CITY OF HARTFORD
DEPARTMENT OF ENGINEERING
SOUTH MEADOWS
PUMPING STATION
MOTOR ROOM FLOOR AND
INTERIOR CONDUIT DETAILS
MAY 29, 1931
SCALE: AS NOTED
MADE: W.B.M. N.S.P. APPROVED: DAYBOOK NO.
CHECKED: W.B.M. N.S.P. 06956

REVISIONS

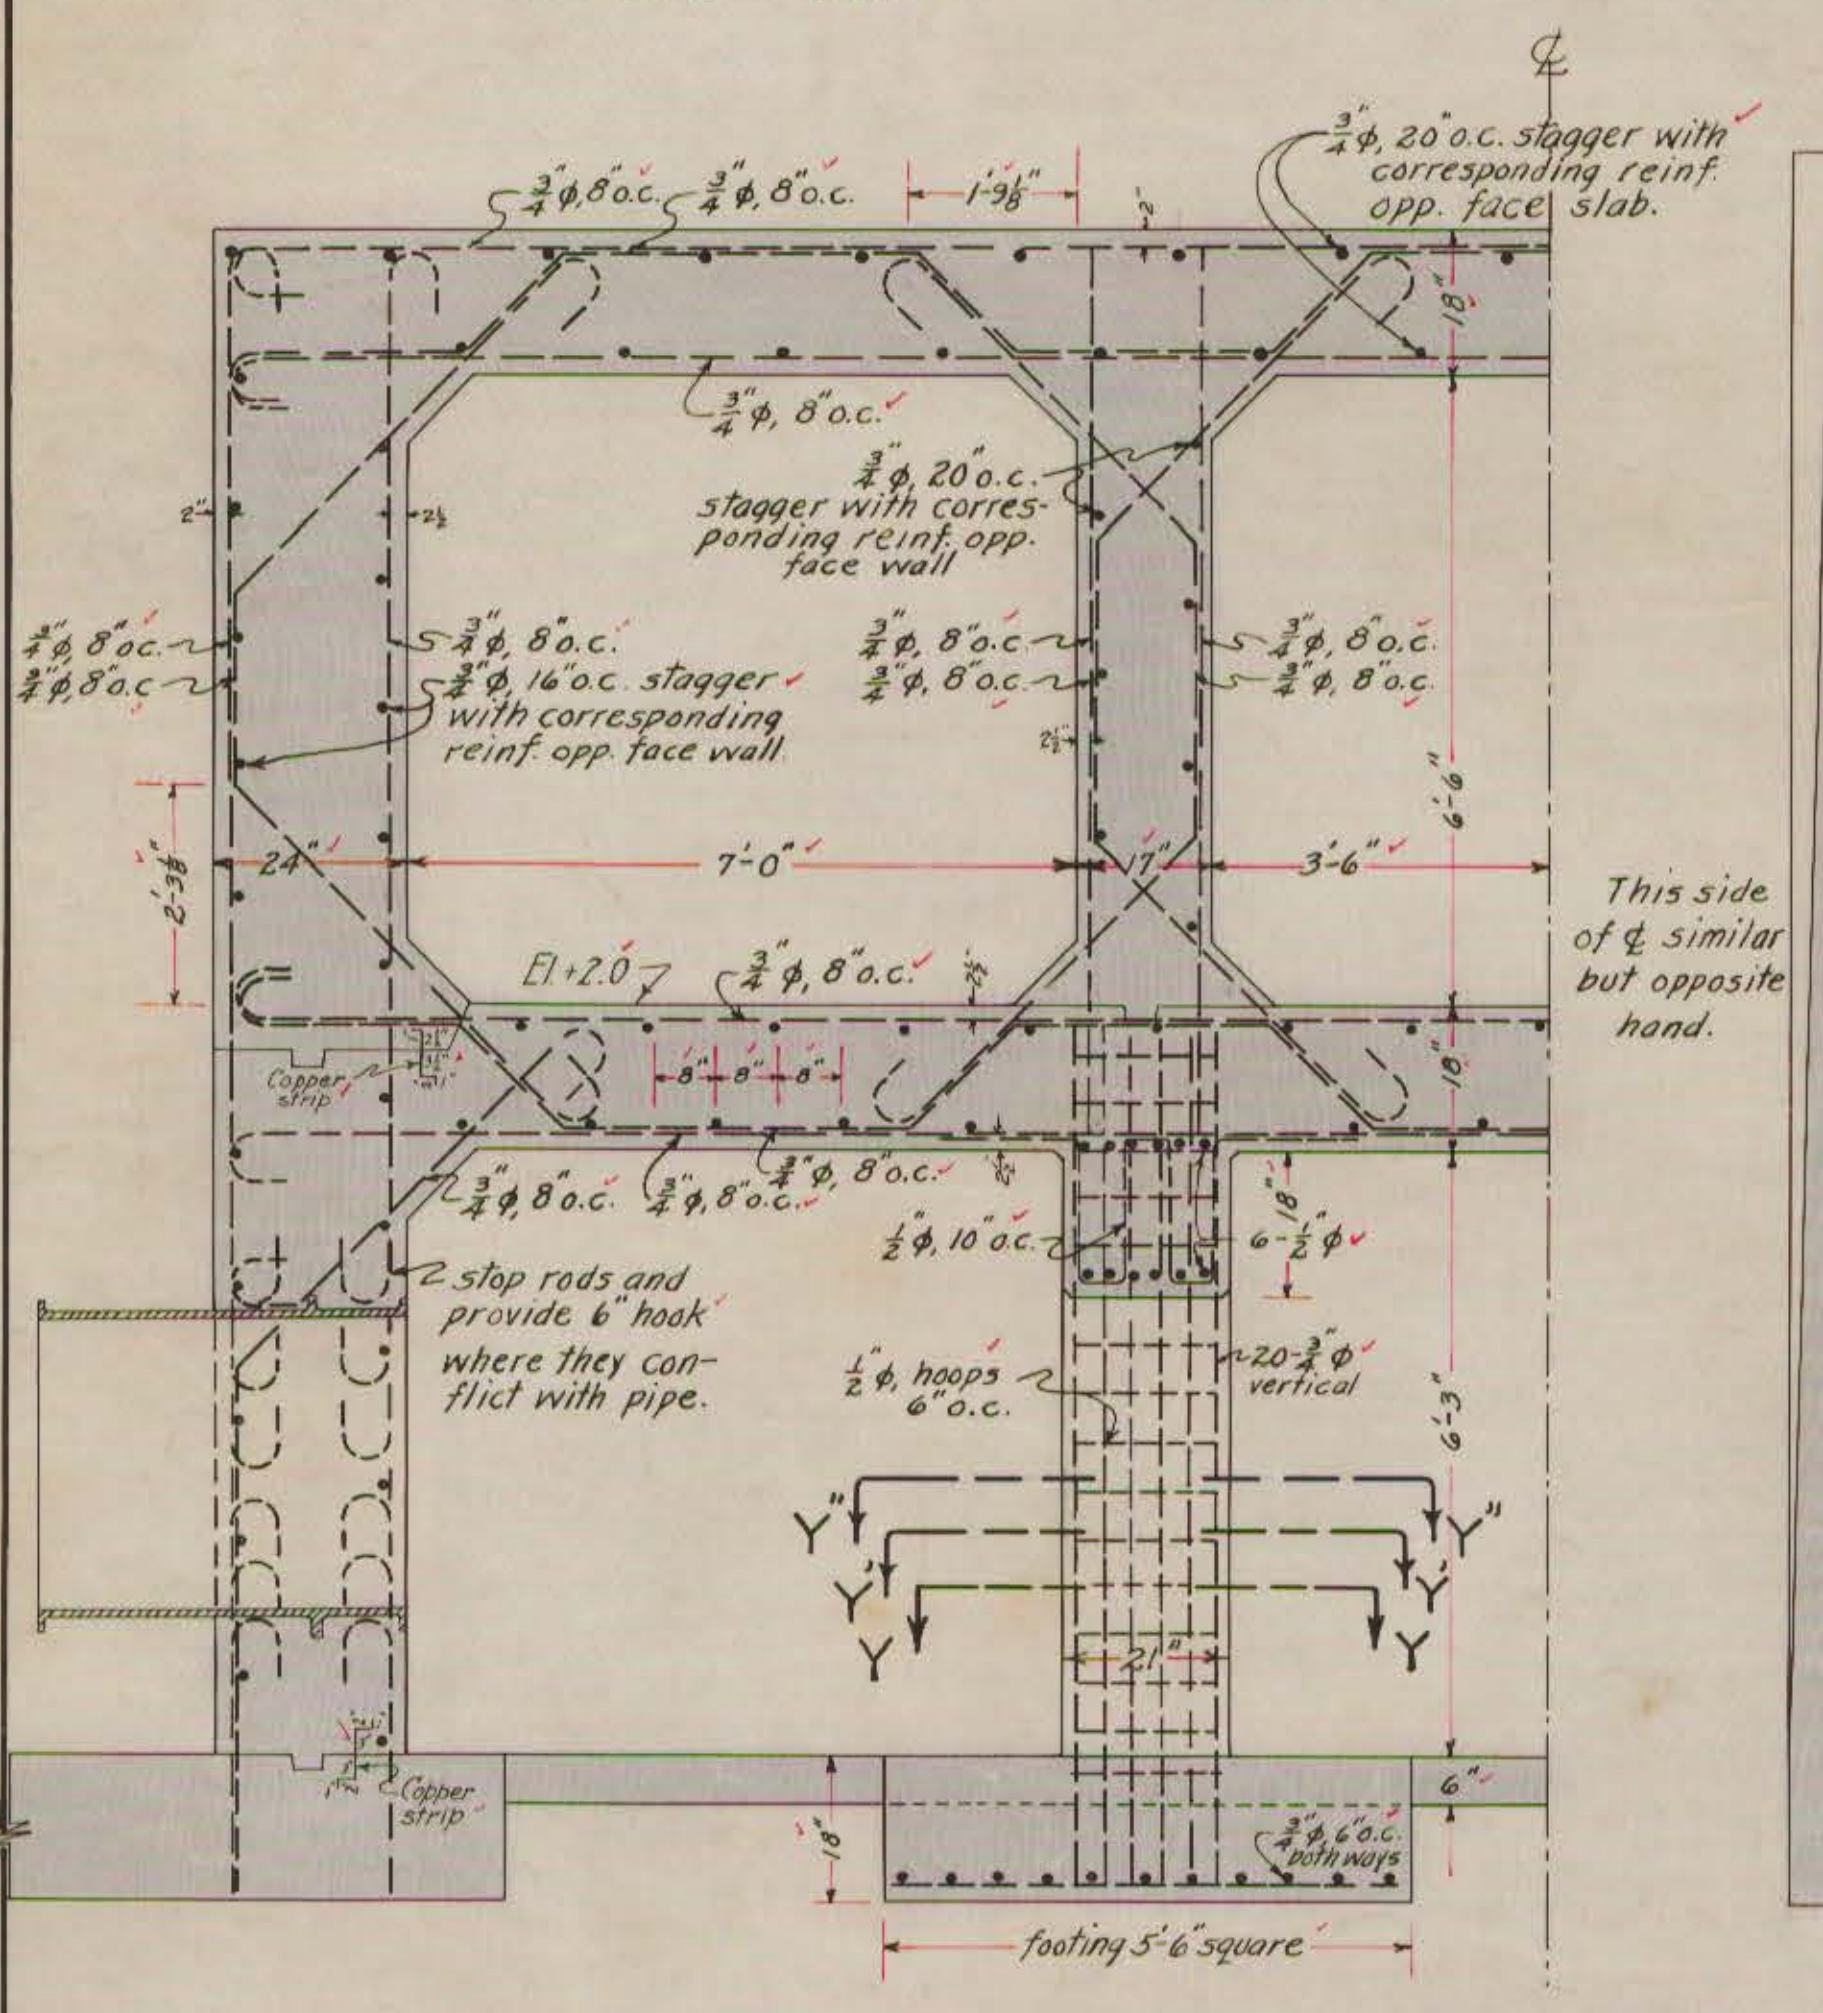
DATE	REVISIONS	BY	APPR
7-1-31	Plan of Motor Room Floor, added sleeves for float switches, S.W. cor.	N.S.P.	N.S.P.
7-2-31	Gate Stand Supports, added rebar, see CC, scale 1/4"=1'-0" section.	N.S.P.	N.S.P.
7-3-31	Details of Covers, corrected position of 2 1/2" P.I.	N.S.P.	N.S.P.
7-4-31	Plan of Motor Room Floor, changed radius ball circle pump motor base	N.S.P.	N.S.P.
7-5-31	SEC. CC' added section that switch pipe	N.S.P.	N.S.P.
7-6-31	Plan of Motor Room Floor, added radii for pipe sleeves, set and pipe sleeves	N.S.P.	N.S.P.
7-7-31	Plan of Motor Room Floor, added dimensions to exciter anchor bolt pipe sleeve	N.S.P.	N.S.P.
8-19-31	Plan of Motor Room Floor, changed radius ball circle pump motor base & 7 1/2"	N.S.P.	N.S.P.
